# HARTING Product Change Notification

PCN / 0048

**Product range:** Han-Modular®

**Title:** PCN 0048: Han-Modular® Compact Coding Pins Design Change

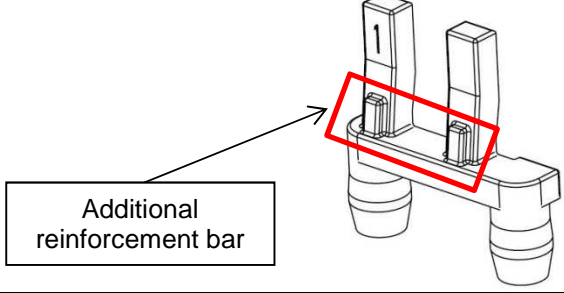
From November 2015 on, the Han-Modular® Compact Coding Pins will be produced in a reinforced design. The new design offers an additional reinforcement bar at the bottom of the coding pin.

Old design:	New design:
09 14 000 9971 (red): 	09 14 000 9971 (red):  Additional reinforcement bar
09 14 000 9972 (blue): 	09 14 000 9972 (blue): 
09 14 000 9973 (black): 	09 14 000 9973 (black):
